**Bayside Planning Panel**

Item No	5.5
Application Type	Development Application
Application Number	DA-2016/402
Lodgement Date	7 June 2016
Property	686-688 Princes Highway, Kogarah
Owner	Tonuja Constructions Pty Ltd
Applicant	Ideas-design Associates
Proposal	Cconstruction of a four (4) storey residential flat building comprising sixteen (16) residential units, rooftop terrace, basement parking and demolition of existing structures
No. of Submissions	Nil
Cost of Development	\$4,051,663
Report by	Creative Planning Solutions P/L

## Planning Assessment Report

<b>Application Number:</b>	DA-2016/402
<b>Date of Lodgement:</b>	07 June 2016
<b>Property:</b>	686 and 688 Princes Highway, KOGARAH NSW 2217 Lot 2 DP 1188540
<b>Owner:</b>	Tonuja Constructions Pty Ltd
<b>Applicant:</b>	Tonuja Constructions Pty Ltd
<b>Proposal:</b>	Construction of a four (4) storey residential flat building comprising sixteen (16) residential units, rooftop terrace, basement parking and demolition of existing structures
<b>Recommendation:</b>	Approval, subject to recommended conditions of consent
<b>No. of submissions:</b>	None
<b>Author:</b>	Patrick Waite – Creative Planning Solutions
<b>Date of Report:</b>	30 M

**Figure 2:** Extract of Height of Buildings Map from the LEP. Noted in this image is the 14.5m building height limit that applies to the subject site and surrounds

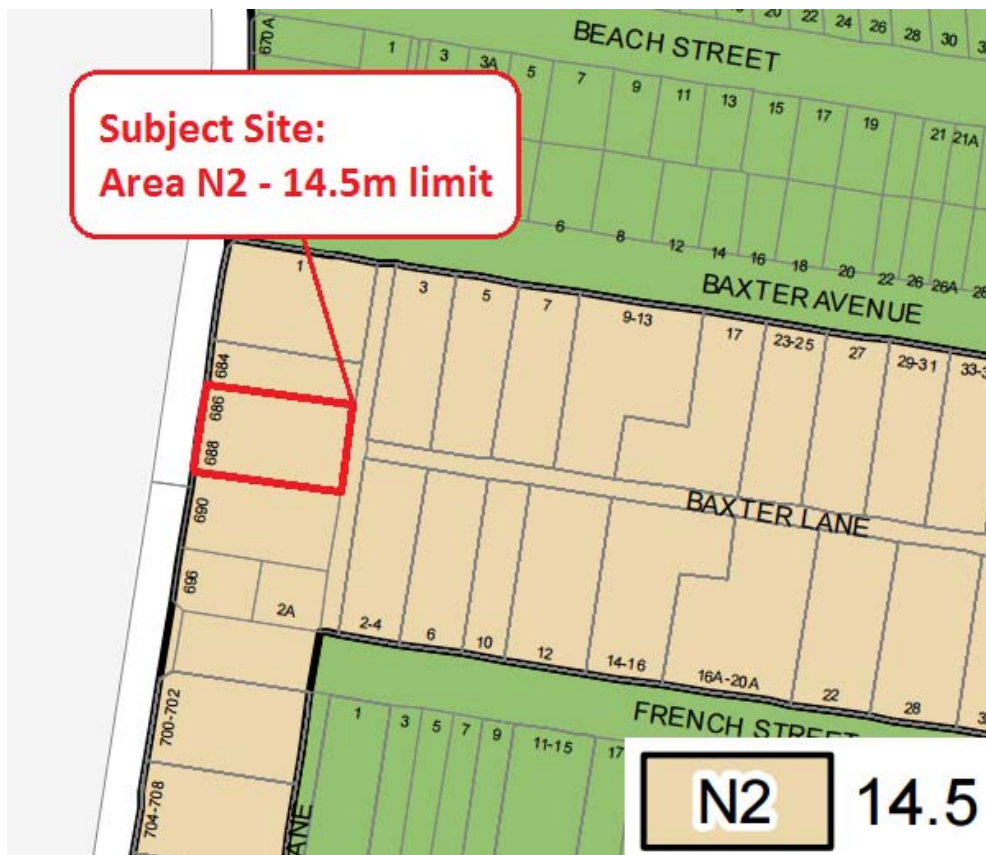
Below is an extract of the Height of Buildings Map taken from the RLEP 2011 which demonstrates that a 14.5m high building height limit applies to the subject site and also the immediate surrounds.

An assessment of the applicant's current plans for the proposal has revealed that the building would fail to achieve compliance with the 14.5m height limit.
